APPLICATION FOR LAYING BUILDING SEWER AND/OR DRAIN SERVICE

Application **Nº 20579**

Re: N.B. Seafood - 28 Kenyon St.

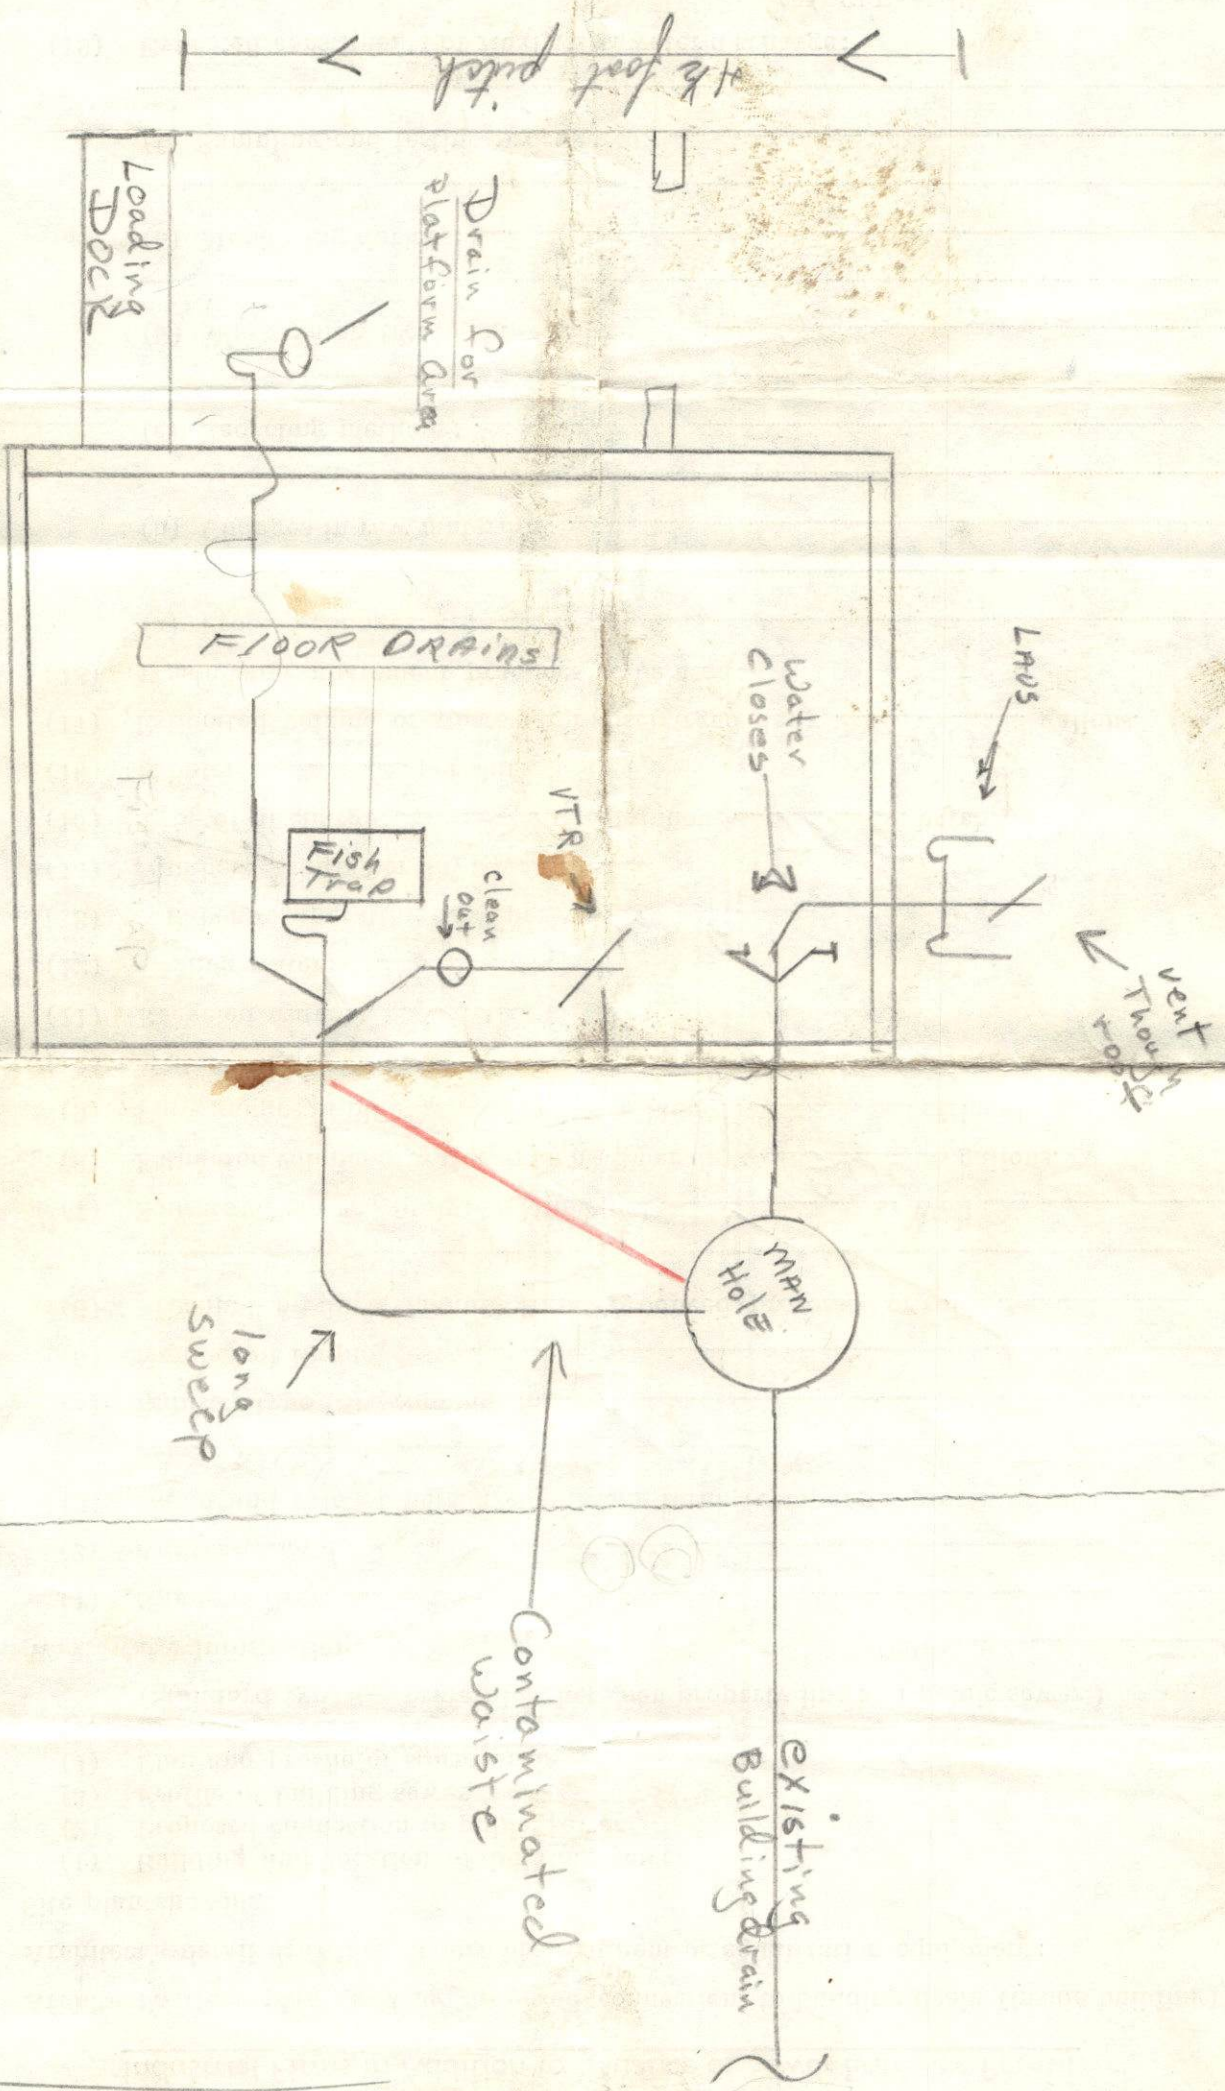
1. Item C of this form requires a "Site Plan" - in my opinion this means a regular engineering drawing to scale and showing the required information.

3. The bldg connection to the control man hole should be as direct as possible with the use of fittings.
